DIKES AND REVETMENT CONSTRUCTION/REPAIR

REPORT OF AS-BUILT CONDITIONS

Contract Description: 2nd M FY14 MRM-195³⁰⁰ Contract No.: W912P9-14-C-0411

River Mile: 258.46 Type of Structure (Constructed/Repaired): WEIR

A1 WEIR 258.4 L PLAN VIEW
SCALE: 1"=40'
STATION QUANTITY = 32,400 IN
N

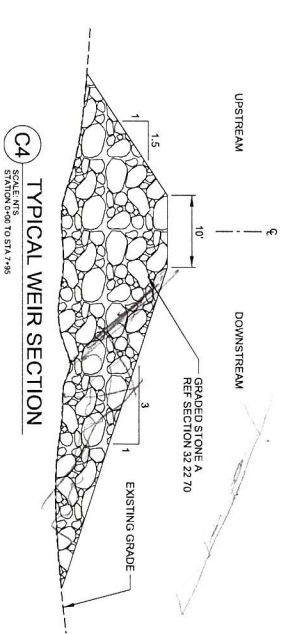
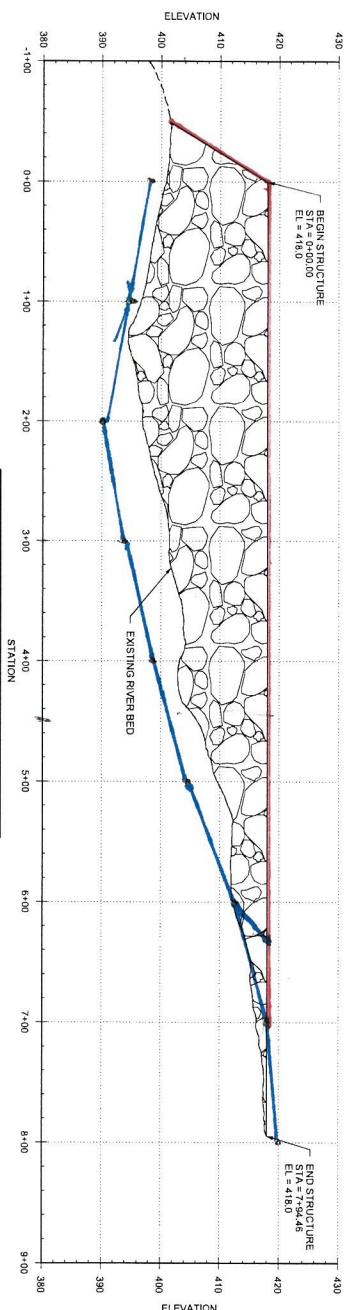
General remarks or unique conditions: cut the WEIR off at 6+30

due to the water being too shallow for fill

C1 WEIR 258.3 L PLAN VIEW
 ESTIMATED QUANTITY = 31,800 IN.
 SCALE: NTS
 STA=0+00 TO STA=6+72.70

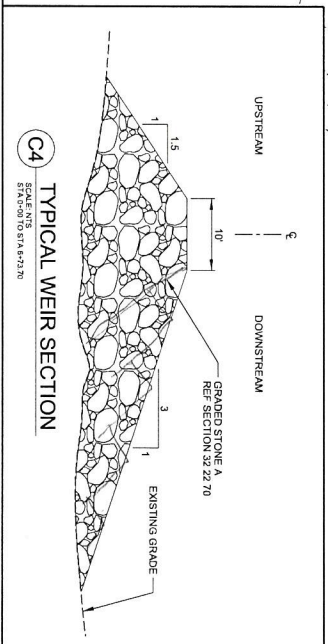
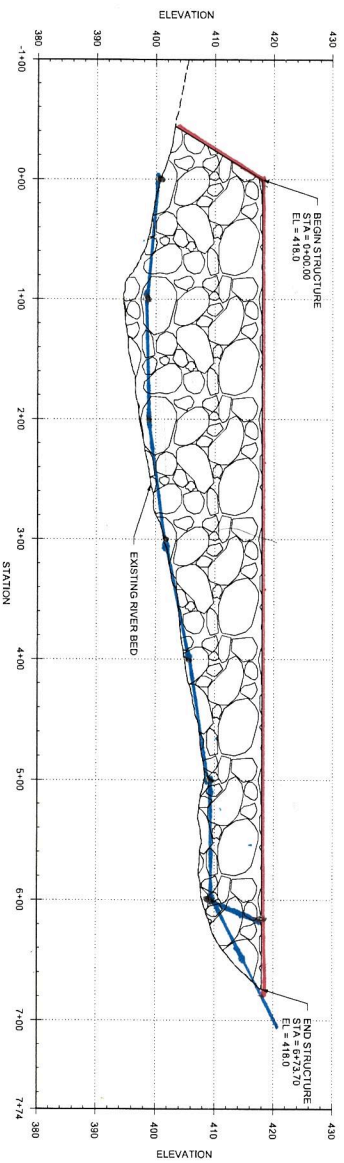
General remarks or unique conditions: Cut the WEIR off at 6+10

due to the water being too shallow for fill.
